MONTGOMERY COUNTY HISTORIC PRESERVATION COMMISSION
STAFF REPORT

Address:	24227 Hawkins Landing Drive, Gaithersburg	Meeting Date:	12/18/2024
Resource:	Master Plan Site #14/14 Bowen-Woodfield Farm	Report Date:	12/11/2024
Applicant:	Muse Kirwan Architects (William Kirwan, Agent)	Public Notice:	12/04/2024
Review:	HAWP	Tax Credit:	No
Permit No.:	1094686	Staff:	Laura DiPasquale
Proposal:	Porch and fenestration alterations, basement alterations

Staff recommends the HPC **approve with three (3) conditions** the HAWP application, with final approval delegated to staff.

Figure 7: South elevation drawings, existing (left) and proposed (right).

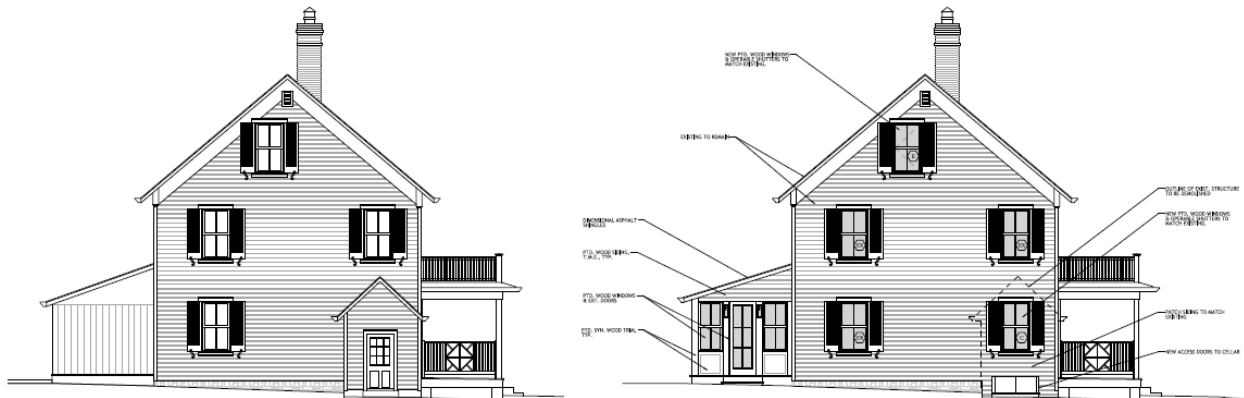
The applicant proposes to remove the existing gable vestibule covering the cellar entrance and replace it with a Bilco (steel) door. At the preliminary consultation review, the Commissioners were split on the removal of the vestibule, with one Commissioner opining that the vestibule appears to be a character-defining feature, while others disagreed and supported its removal. Commissioners requested additional information for the HAWP. The applicants have subsequently submitted additional photographs and written explanation noting that there are rubble walls on either side of the basement stairs, but a concrete foundation and steps beneath the vestibule. The applicants state that it is their opinion that, “while there may have been a cellar access door here originally, our professional opinion is that it is more likely that the original entrance was an historic low sloped cellar access door and that the existing structure above the stone foundation was built at a later time possibly to protect against rain water intrusion.”

Staff has not determined the precise age of this vestibule but notes that the detailing is similar to that of the main house with matching Dutch lap siding, slate roofing, overhanging eaves, and other details that suggests it was added in the early 20th century, but may not be an original feature of the dwelling. The proposal calls for a new two-over-two, double-hung, wood-sash window that matches the design, material, and dimensions of the other windows on this elevation in the location of the demolished vestibule. Staff finds that the alteration would not substantially alter the exterior features of the site and that the proposed window and Bilco door are compatible with the historic site, in keeping with Chapter 24A-8(b)(1) and (2).

Figure 10: Photograph of the south elevation attic window (left) and proposed south elevation drawings (right). The red circle show the location of the window proposed to be replaced.

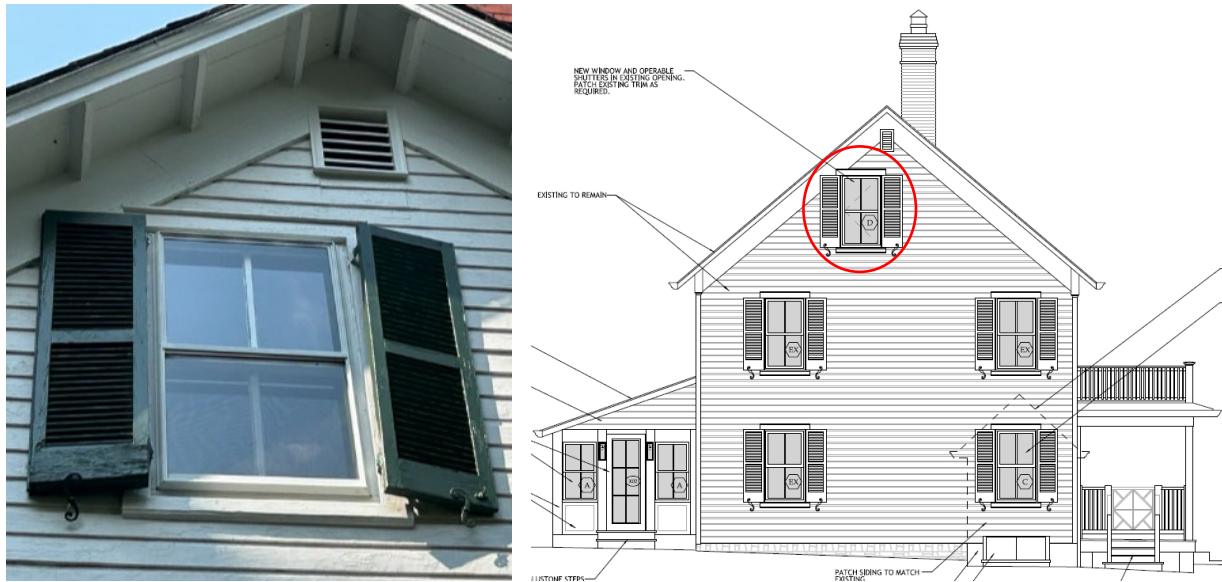
The applicant proposes to replace an existing double-hung window with a casement window of matching dimensions (*Figure 10*). The applicant explained at the preliminary consultation review that they propose to replace the double-hung window with a casement with a simulated meeting rail and muntins in order to meet egress requirements for a habitable room. The applicants have not provided dimensioned drawings of the window beyond the elevation drawing, non-dimensioned 3D view of the window unit and the written window schedule, but confirmed by email to staff that the window differ from the existing window in that it will all be in one plane as opposed to the existing off-set upper and lower sash. Staff notes that the window schedule identifies all windows as having 7/8-inch muntins, but recommends that the dimension be confirmed, as 1-1/8 to 1-1/4 inch vertical muntins are typical for historic two-over-two windows. Staff finds that, provided the dimensions of the muntin, faux meeting rail, and installation details match the existing window, the lack of offset will be a minor change and will remedy a potentially unsafe condition by creating a means of egress, in keeping with Chapter 24A-8(b)(4).

1. The north attic window must be reduced in size to avoid impacting the bargeboard, and the shutters eliminated.
2. The new steps proposed on the south side of the front porch must be constructed of wood.
3. The applicant must submit dimensioned window specifications and/or window installation details for the proposed new and replacement windows. The proposed replacement window on the south elevation must match the dimensions of the existing window.

Figure 14: Revised site plan with red arrows showing the proposed bluestone walkways and terrace south of the house. The proposed new porch steps on the south end of the front porch are circled in red.

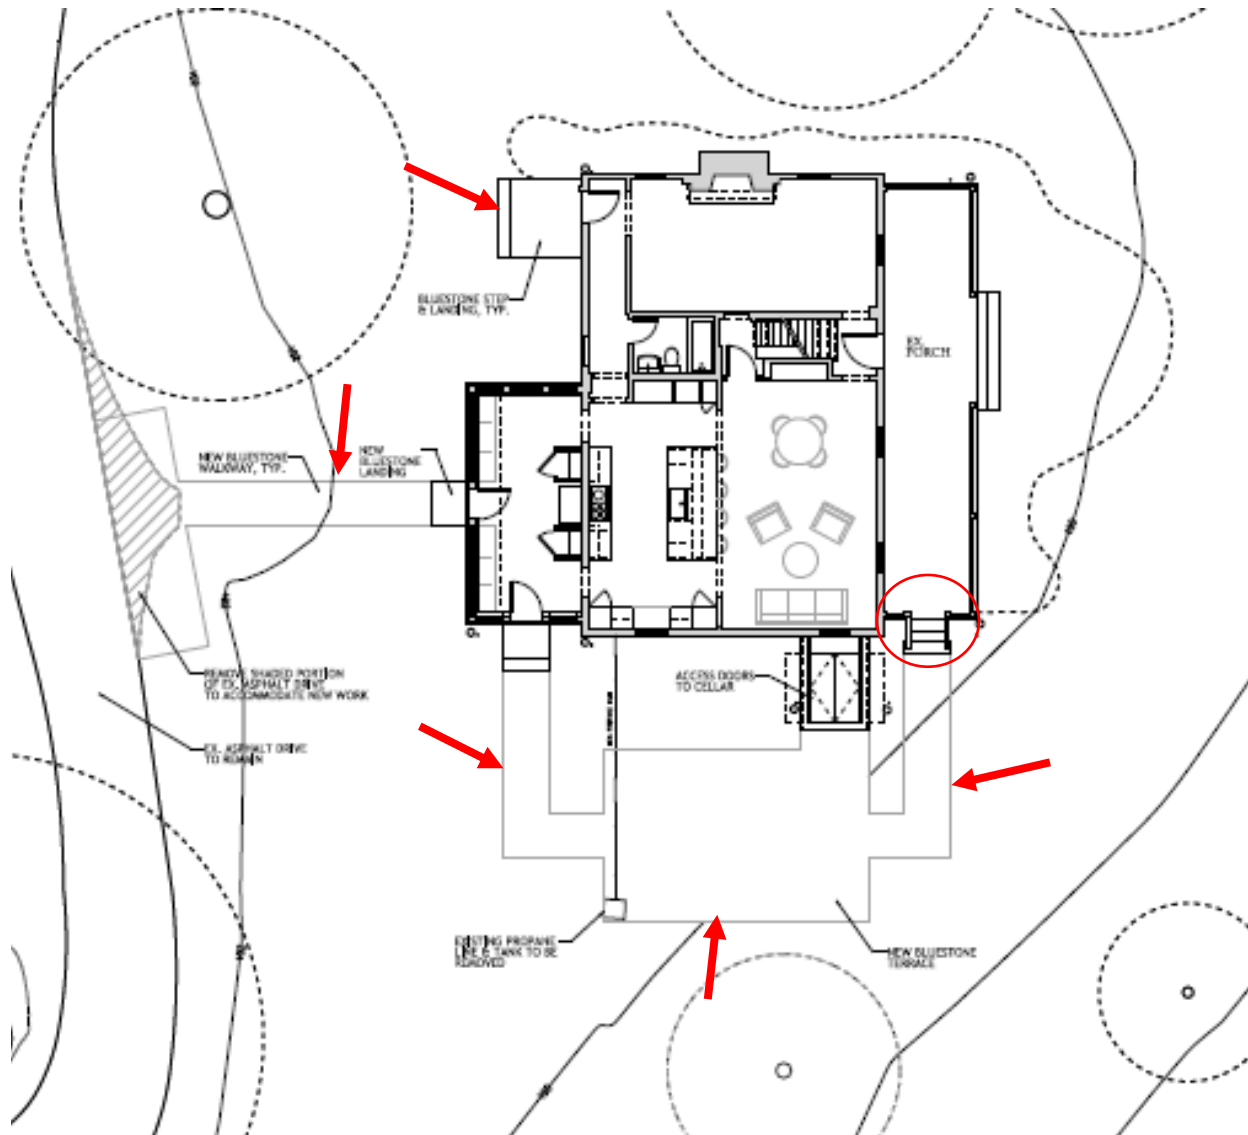
The applicant proposes to install a new terrace adjacent to the south elevation of the house with walkways accessing the east and west elevations and extending from the addition west to the driveway. The HPC did not express any concerns about the proposed terrace or walkways during the preliminary consultation review.

Following the preliminary consultation review, the applicant modified the proposed bluestone path to the existing front porch steps to a new set of synthetic wood steps to be added to the south end of the historic front porch. A portion of the existing porch railing would be removed to accommodate the new steps. Staff notes that the use of synthetic wood on a Master Plan-designated historic porch is out of keeping with the HPC’s Policy No. 24-01 and must be revised to show wood steps.

A note on the cover sheet indicates that “additional grading will be necessary to accommodate new terraces etc...” Staff notes that the modified grading was not shown in the preliminary submission, nor in the HAWP submission as requested in the preliminary consultation report, and that the terrace and some walkways are not shown in elevation or section, despite those items being requested in the preliminary consultation report. Provided the grading and excavation are surface-level only, staff finds that a bluestone paving material is compatible with the historic property and that proposed walkways and terrace will not have an adverse effect on the historic property, and will satisfy *Standards #2 and #9*.

1
A201
PROPOSED NORTH ELEVATION
SCALE: 1/4" = 1'-0"

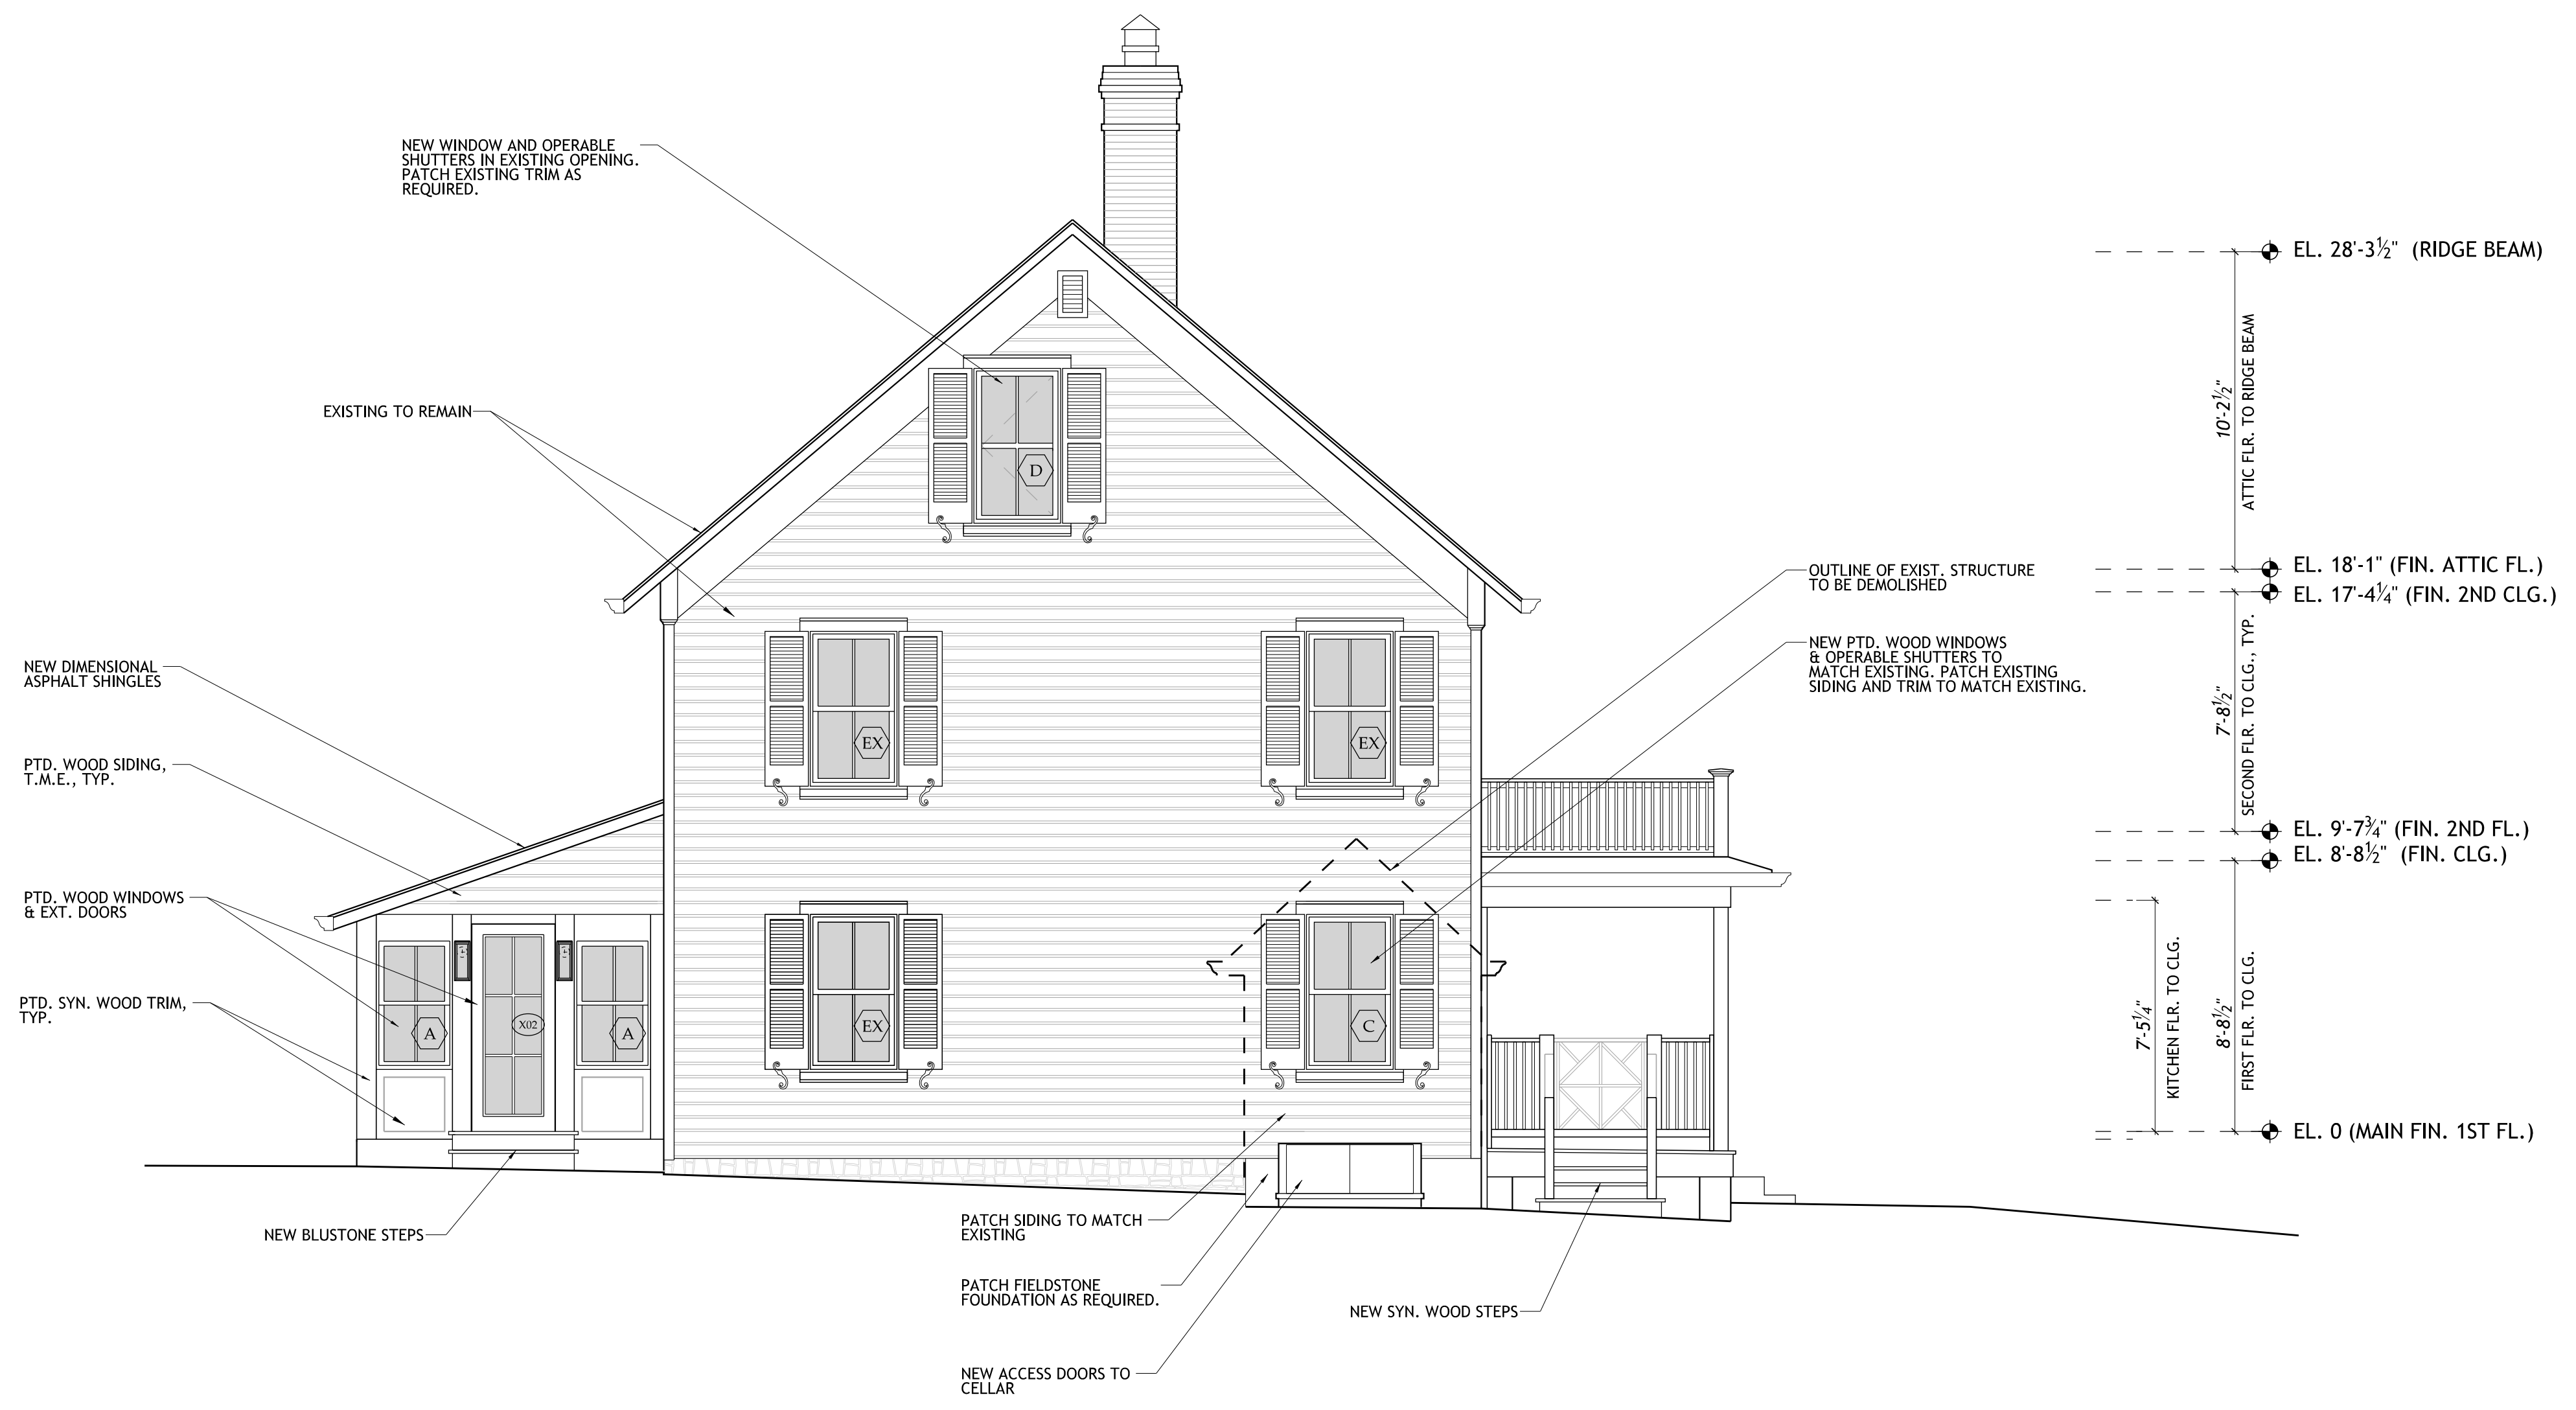
- Opinions were mixed on the proposed north window. Some Commissioners suggested reducing the size of the window to avoid impacting the bargeboard and eliminating the shutters, noting that it was not unusual for attic windows of this period to be smaller and to not have shutters. One Commissioner supported the window as proposed.

The applicant proposes to install an attic-level casement window with shutters abutting the gable end exterior brick chimney. The window would match the proposed new casement window on the south elevation in dimensions and appearance. This size and location of the proposed window would directly affect the original bargeboard. Staff finds that the scale of this window is inconsistent with the character of the dwelling. While the south elevation features a similar window in its attic, that elevation lacks an exterior chimney. Most houses of this era with an exterior chimney feature smaller windows in the attic compared to the lower stories. At the preliminary consultation review, the Commissioners present had mixed opinions on the proposed north window. Some Commissioners suggested reducing the size of the window to avoid impacting the bargeboard and eliminating the shutters, noting that it was not unusual for attic windows of this period to be smaller and to not have shutters. The applicants argued that the window matches that on the south elevation. One Commissioner supported the window as proposed. No changes have been made to the proposed window following the preliminary consultation. Staff notes that the north and south elevations are not identical, and that creating a false sense of historical development is expressly discouraged by *Standard 3*. Staff recommends that the size of the window be reduced to avoid impacting the bargeboard, and the shutters removed, finding that, with revisions, the proposed window would be compatible with the historic resource, in keeping with Chapter 24A-8(b)(2), and differentiated from but compatible with the historic resource, in keeping with *Standard 9*.
